SIB 65 20 19

2023-05-04

RECALL CAMPAIGN 19V-698: DRIVER'S FRONT AIR BAG MODULE – PRIOR PARTS REPLACEMENT

This Service Information Bulletin (Revision 5) replaces SI B65 20 19 **dated March 2023**.

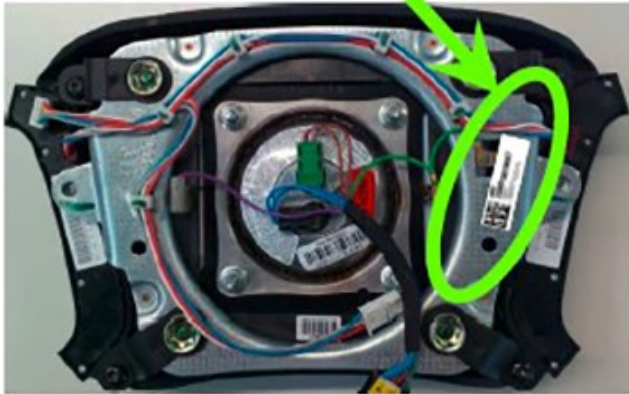
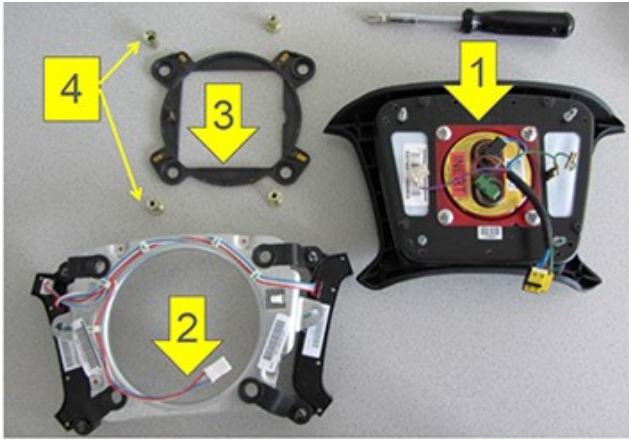
<p>1. Remove the driver's air bag in accordance with repair instructions REP 32 34 020 "Removing and installing/replacing air bag units".</p>
	<p>2. Check the label on the back of the driver's air bag.</p> <p>Is the label yellow with a white number sticker with printed serial number BAM PT1-1085 (as shown on left) printed below the bar code?</p> <p>YES- replace air bag</p> <p>NO - the driver's air bag is not affected.</p> <p>Reinstall the driver's air bag.</p>

Note:
 Air bags from other manufacturers (non-Takata), or Takata air bags with different chemical compositions (white label) are not affected by this recall and **DO NOT** need to be replaced.

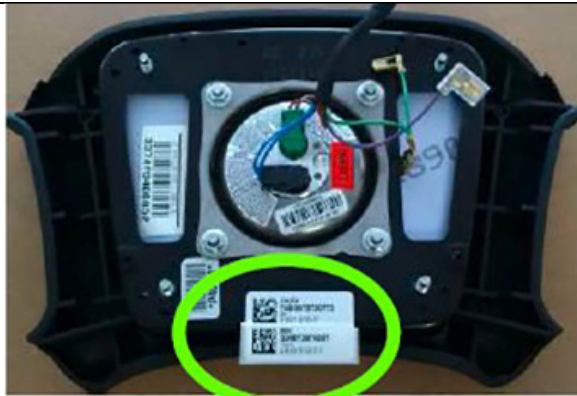
On vehicles with a basic steering wheel, the horn ring must be removed from the new part. To do so, proceed as follows:

<p>1. Remove horn ring.</p> <ul style="list-style-type: none"> • Unplug the connector for the grounding cable (see the green arrow in the figure) • Remove the nuts (see the blue mark in the figure, Torx 55).
	<ul style="list-style-type: none"> • Take off the horn ring, making sure that the springs remain in place. • Remove the horn contact plate. • Separate components after disassembly: <ol style="list-style-type: none"> 1 - Air bag module 2 - Horn ring 3 - Horn contact plate 4 - Torx nuts

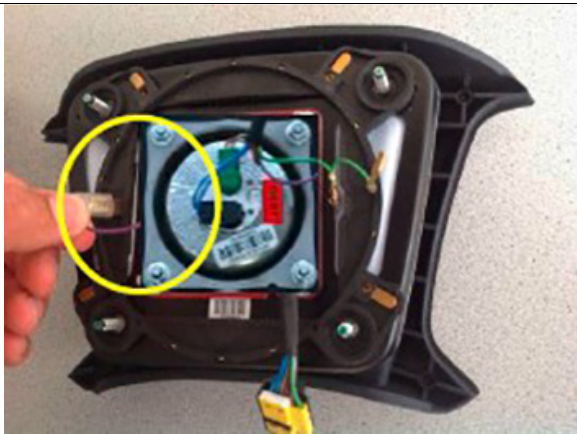
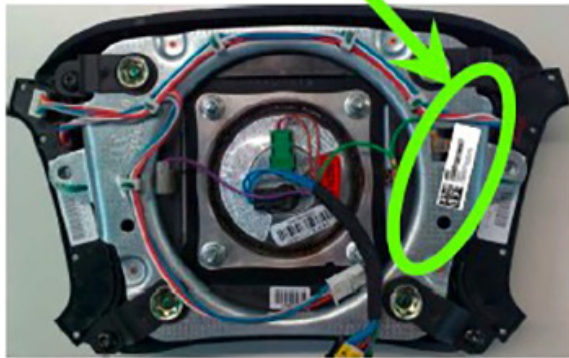
2. Prepare the new air bag module and pull off one of the two labels with the barcode and serial number of the air bag module.

This must be applied to the horn ring **after** installation.

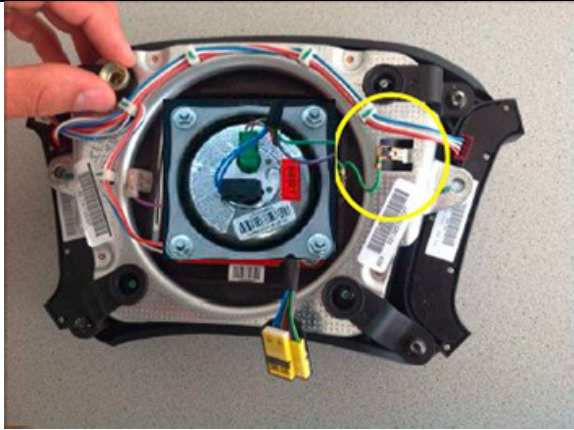
3. Place the horn contact plate on the new air bag module and plug in the connector.
